State of Oregon
Department of Environmental Quality

Subject: Addendum – Clarifications to John Day River Basin TMDL

Date: September 16, 2011

Figure B-18. Predicted maximum 7DADM temperatures on North Fork John Day River during the model period of 2002. Model results produced every 100 m, except Natural Thermal Potential was modeled 200 m.

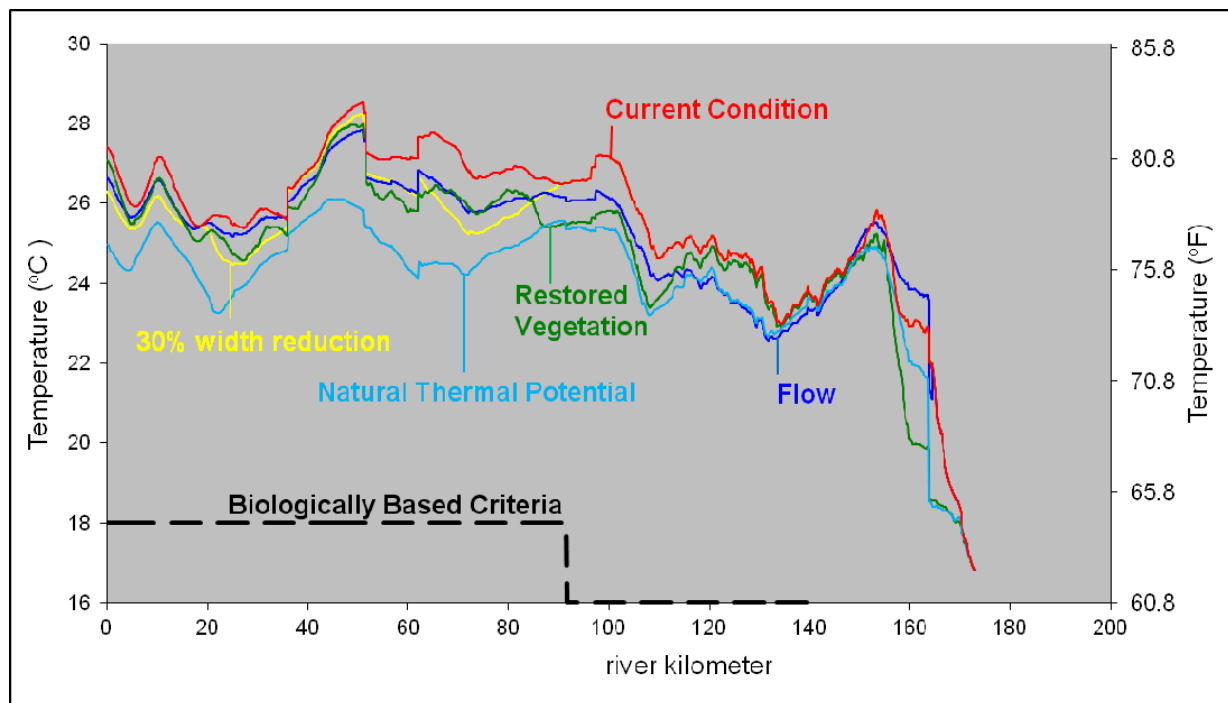
This memorandum amends Appendix B of the John Day River Basin Total Maximum Daily Load (TMDL) document of December 2010. Figure B-18 was incorrectly placed in the document as the same as Figure B-32. Figure B-18 was in error and should be replaced with the figure below. The error was limited to Figure B-18 in Appendix B and did not impact the calculation of TMDL loading capacities (Section 2.4.1(d)) or the determination of nonpoint source loading allocations (Section 2.1.8(h)) as expressed in the final TMDL document. The corrected figure is presented below.
